# ***THE FATE OF PUNE'S RIVERS!***

***-A Reflection on the Proposed Navigation Plan-***

# CRITICAL ANALYSIS OF THE PROJECT

RESPONSE TO PMC FOR NAVIGATION  
PROJECT FROM EXPERTS/VARIOUS  
DEPARTMENTS

### CHANNEL SECTION DESIGN : CROSS SECTION UP TO SANGAM ( DESIGN FLOOD 60,000 )

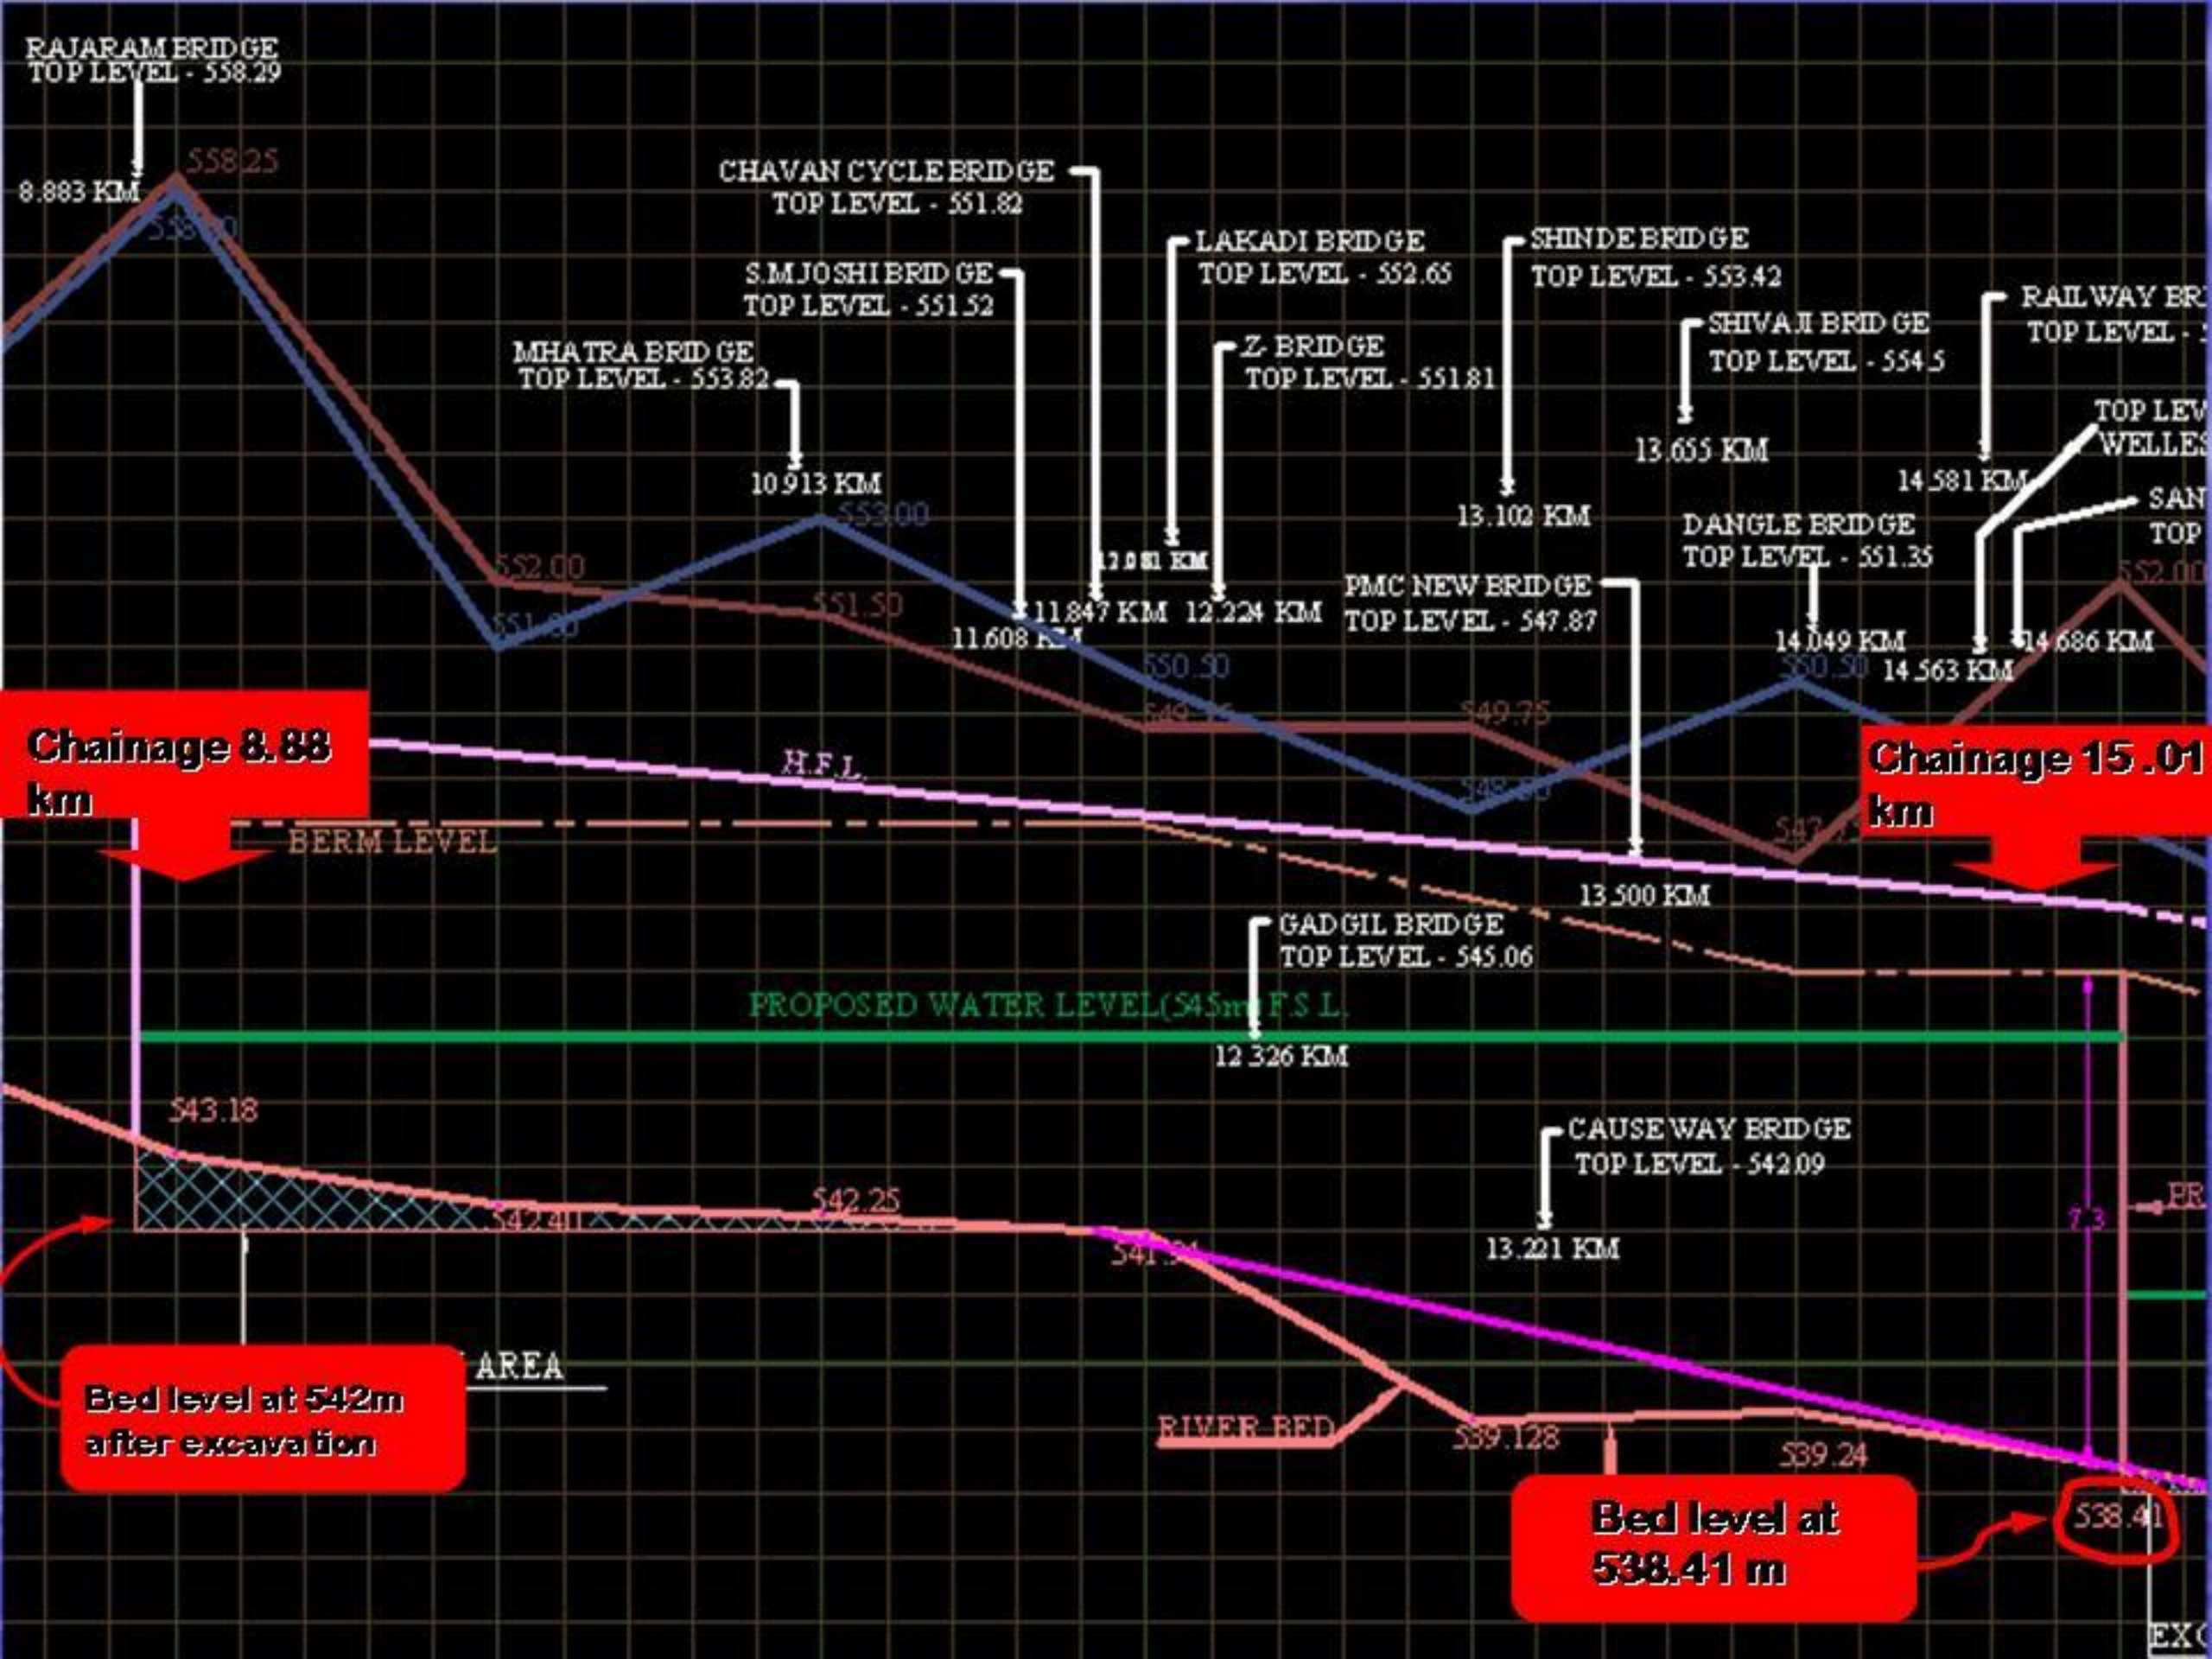
**DUE TO ROCK CUTTING IN RIVER BED, ACTUAL SLOPE WORKS OUT TO 1:1707.**

**THIS RESULTS IN FURTHER REDUCTION IN WATER CARRYING CAPACITY**

# HISTORY OF DISCHARGES FROM KHADAKWASLA DAM

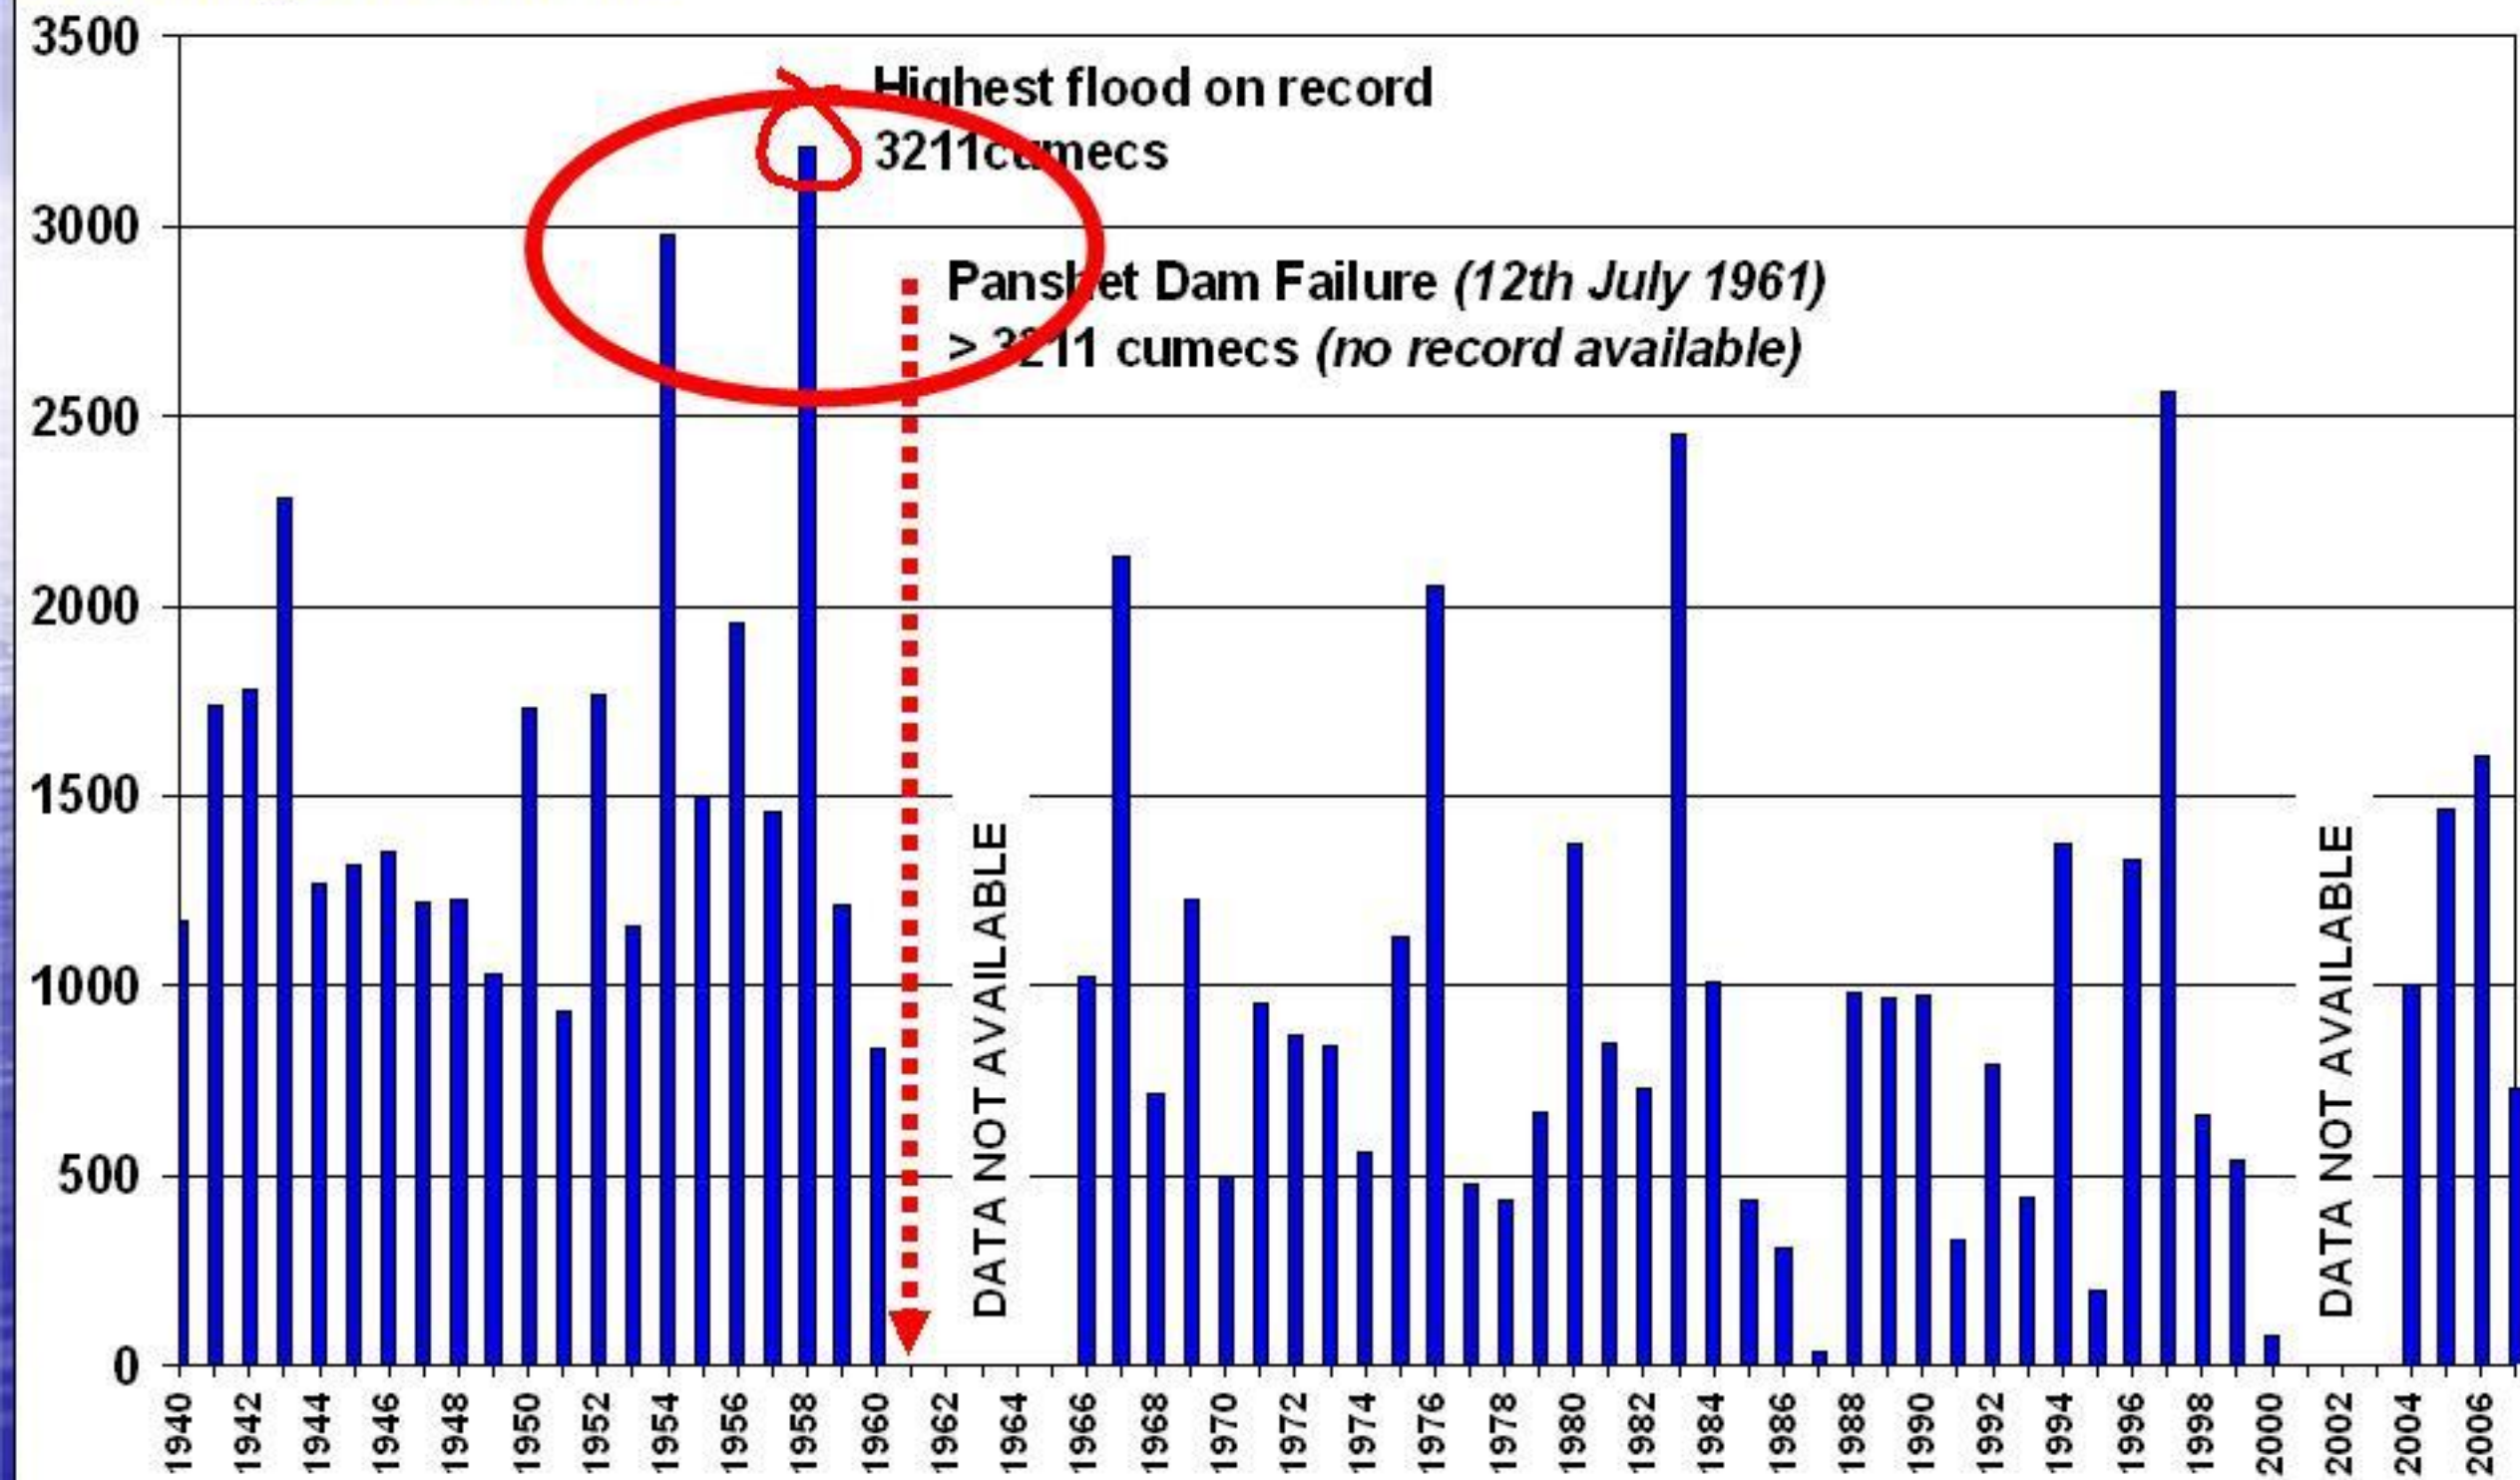
- Actually Pune has received discharge of more than 102982 Cusecs (2925.63 Cumecs) 3 times in last 57 years (1954-2950 Cumecs, 1958-3211 Cumecs & 1961->3211 Cumecs).
- Thus the frequency works out to: every 19 years.
